# HUGHES SERVICE INFORMATION NOTICE

NOTICE NO. N-16.1

## FIELD MODIFICATION - TAIL ROTOR ASSEMBLY

All 269 Series Helicopters

# FIGURE 1. BALANCE WEIGHT INSTALLATION

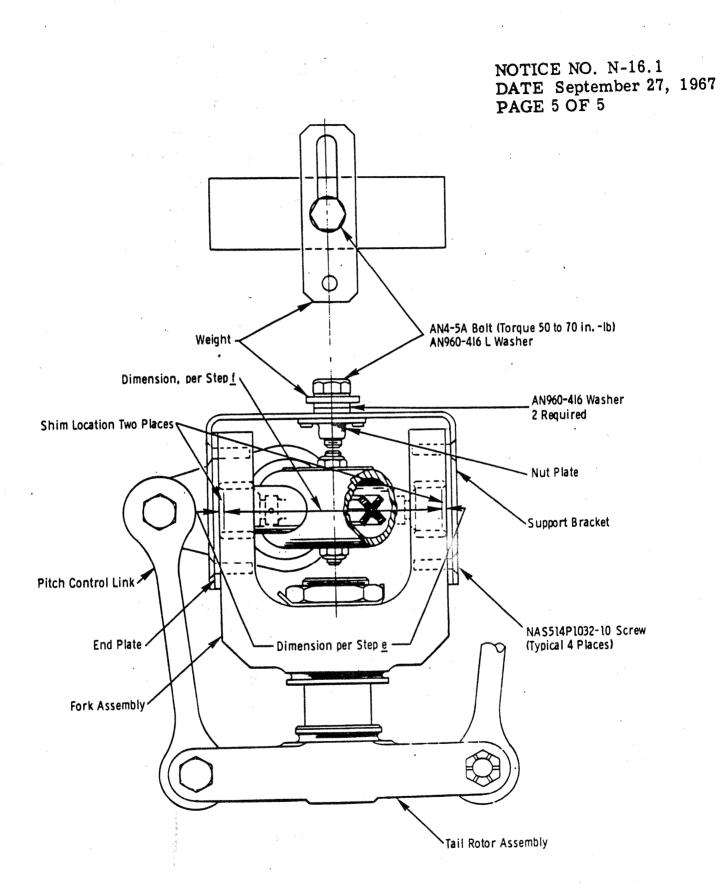
e. Using micrometer, measure and record dimension across two flats of fork assembly. (See Figure 1)

m. Position balancing weight support bracket over two end plates. (See Figure 1.)

p. Secure balance weight assembly to support in following sequence: bolt, thin washer, weight, two washers; torque bolt 50 to 70 in. lbs.

Position weight perpendicular to support so weight is equidistant on each side of support.

Weight adjustment is accomplished by moving weight assembly to either left or right of centerline of support. If vibration increases after moving weight, return to original position then move weight in opposite direction. If vibration decreases, continue to move weight in same direction until vibration is gone or is least apparent. A bolt, nut and washers may be added to weight assembly for more weight, if required. NOTICE NO. N-16.1 DATE September 27, 1967 PAGE 4 OF 5
